To: Massachusetts Distribution Companies and Department of Energy Resources
From: Peter Shattuck, Anbaric
Date: February 25, 2021
RE: Draft Request for Proposals for Long-Term Contracts for Offshore Wind Energy Projects

Figure 1: ISO-NE Identification of Injection Capabilities of Nearshore POIs

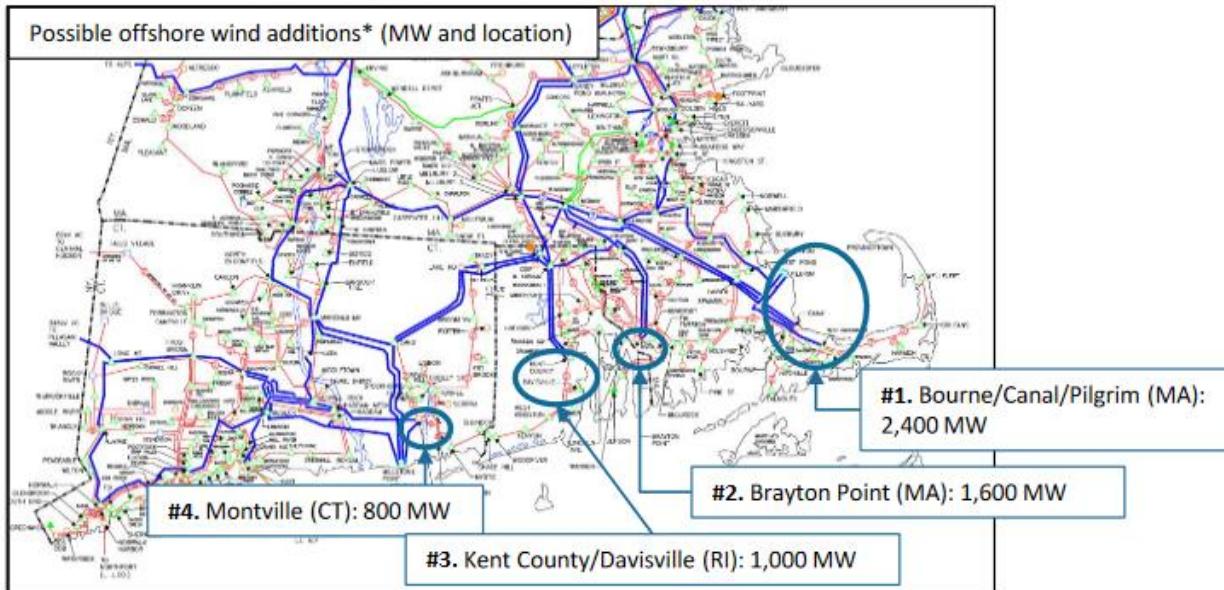
value. ISO-NE's Economic Study carried out for Massachusetts and other members of the New England States' Committee on Electricity (NESCOE) found that POIs proximate to the offshore Wind Energy Areas have limited capacities to receive offshore wind injections before major upgrades (new 345kV circuits in new rights of way) are required (see Figures 1 and 2).ⁱ
